**SCOPING COMMENTS
DARBY LUMBER PROJECT**

RCORUA RECOMMENDED LOOP ROUTES

DARBY LUMBER PROJECT
SECTION 13, T3N, R19W
THE BIG PICTURE

This letter constitutes the Scoping comments from the Ravalli County Off Road User Association (RCORUA) for the proposed Darby Lumber Lands project. As you know, RCORUA has been an active partner with the Forest Service on this project for the past four years and RCORUA volunteers have provided nearly 800 hours of their time characterizing the road systems on the Darby Lumber sections and recommending OHV loop systems that might utilize some of the existing roads in the project area.

**Loop 1 Recommendation
Loop 2 Recommendation
Crystal Mtn. Area Routes**

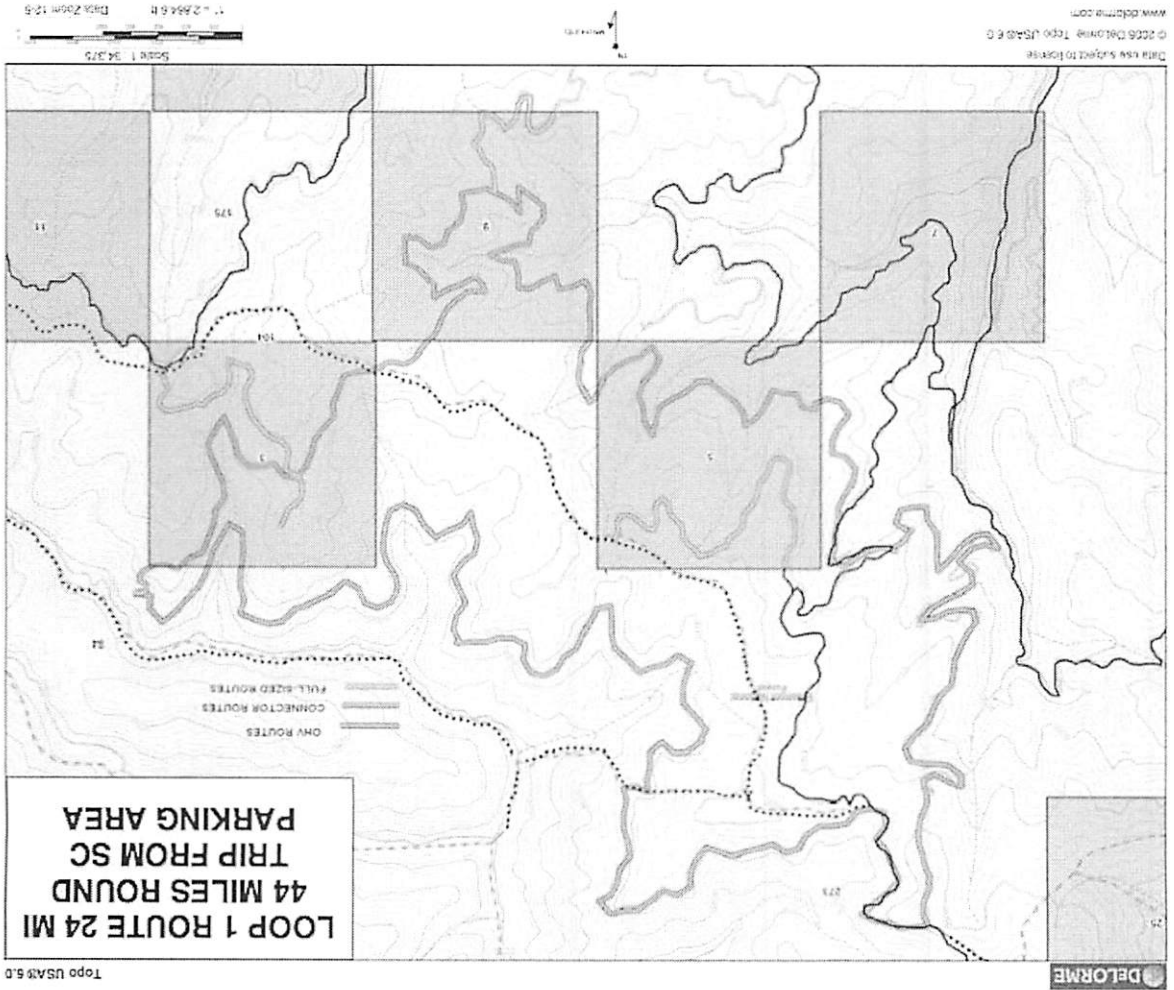
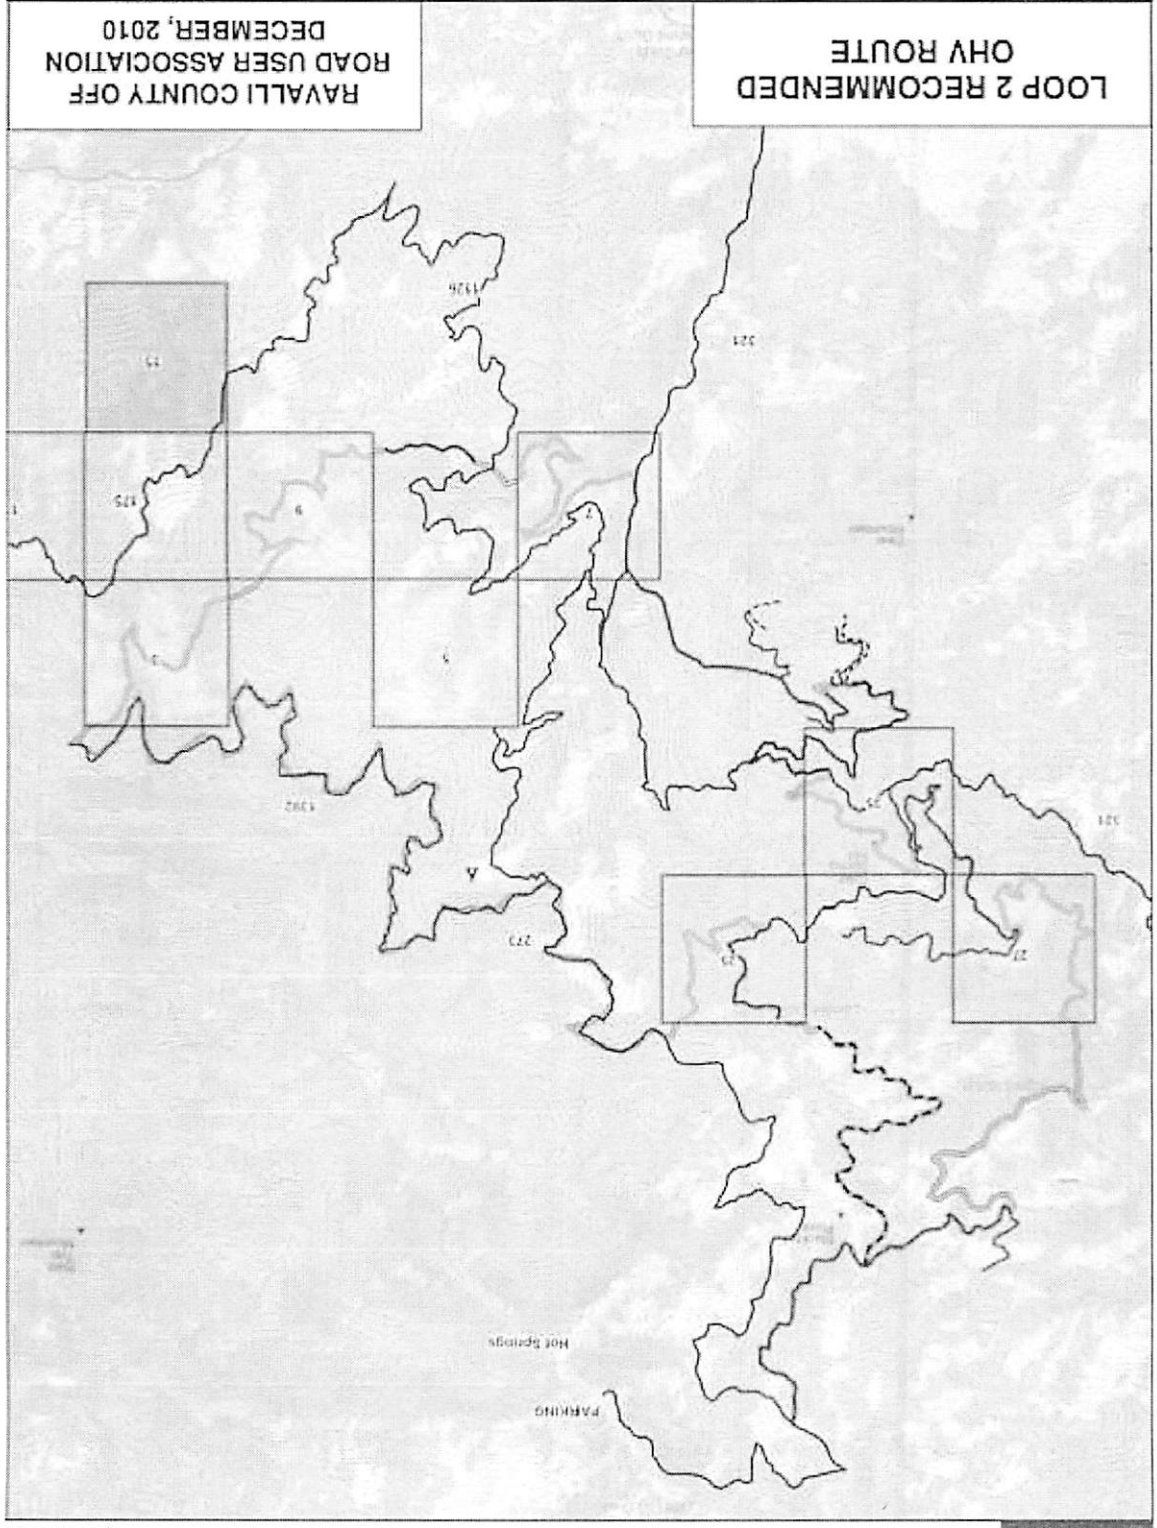
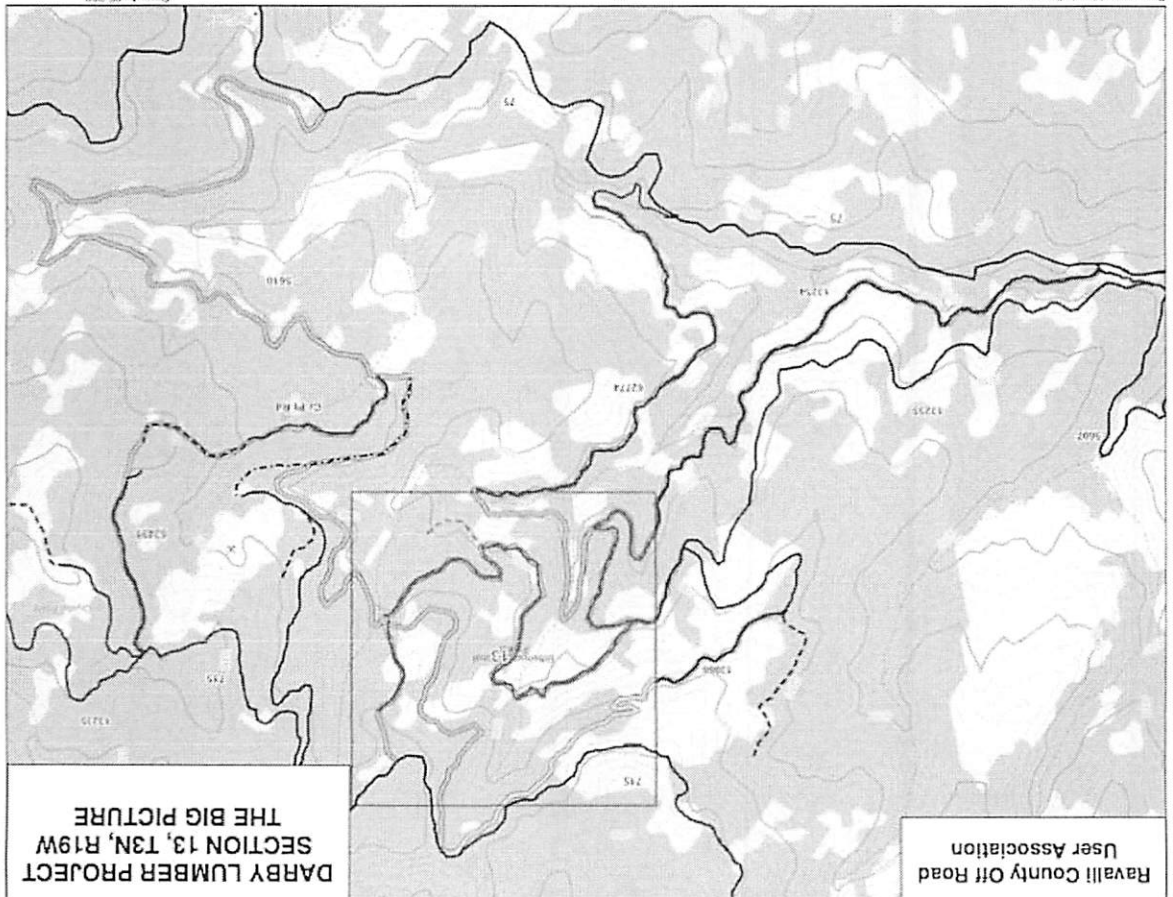
Our Loop 2 proposal lies largely in Darby Lumber Sections 25, 27, 35 and adjacent sections. All of these sections except the eastern portion of section 35 lie within the boundaries of Phase II. Thus it is possible that roads in Section 35 could be decisioned in Phase I without an opportunity to consider the impacts of that decision on our Loop II proposal. We strongly recommend that the Phase I boundary be changed to exclude all of Section 35 (Cold Spring Hill). In other words, the road systems in Sections 25, 27, 35 and adjacent sections are logically connected and should be considered in the same Phase of the project.

We are very pleased and grateful that the proposed action includes some of our recommendations for the designation for OHV routes as part of the project. We request that the Agency reconsider some of the details of our Loop 1 proposal, include our recommendations for OHV loops in the vicinity of the Crystal Mine, and include our Loop 2 proposals that fall within the Phase I project boundary.

APPENDIX II: Maps of RCORUA's OHV loop route recommendations: Loop 1, Loop 2, and Crystal Mountain Routes.
